**PLANNING COMMISSION  
STAFF REPORT**

November 7, 2024

AGENDA ITEM: Planning File No. MAJ-24-0003: A final plan review of an attached townhome development located at 909 Lakepoint Circle.

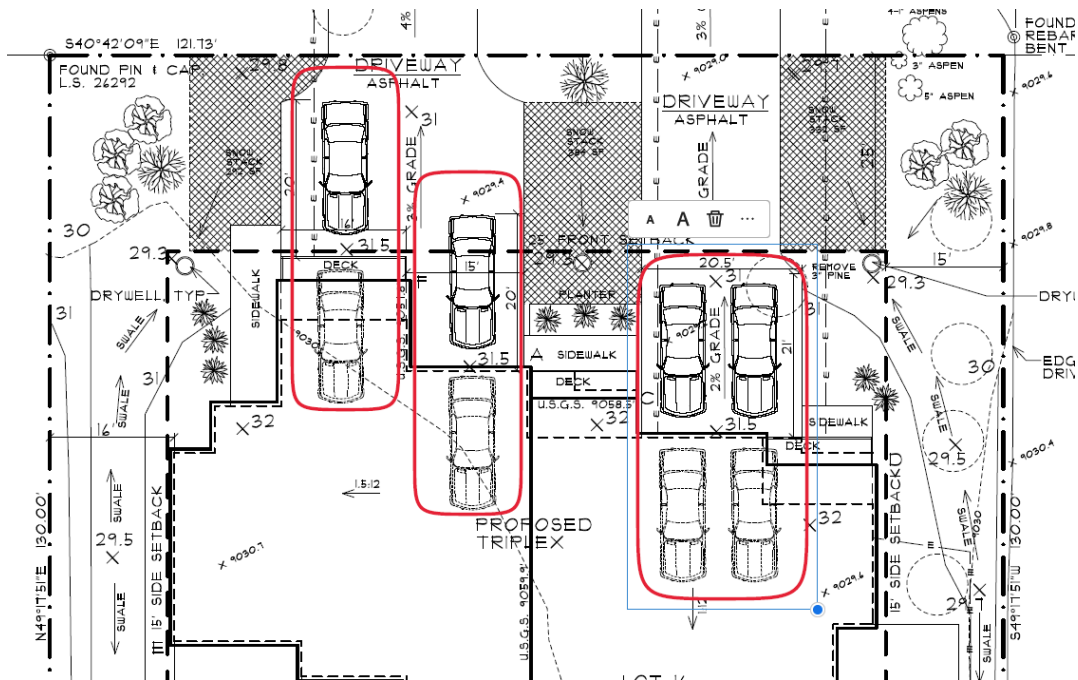
**Tandem Parking** (§180-6.13.6): For multifamily residential projects, two stacked (tandem) spaces may be permitted if the Planning Commission finds that the layout of the parking is functional and, at a minimum, finds two out of the following four criteria are met:

The Application shows tandem parking. The proposed tandem parking shows two stacked tandem spaces on two units, and the third unit has two tandem spaces for a total of four (4) parking spaces. The Application shows the tandem parking complies with 180-6.13.6. At the time of the sketch plan, the Planning Commission was in support of the tandem parking layout as proposed.
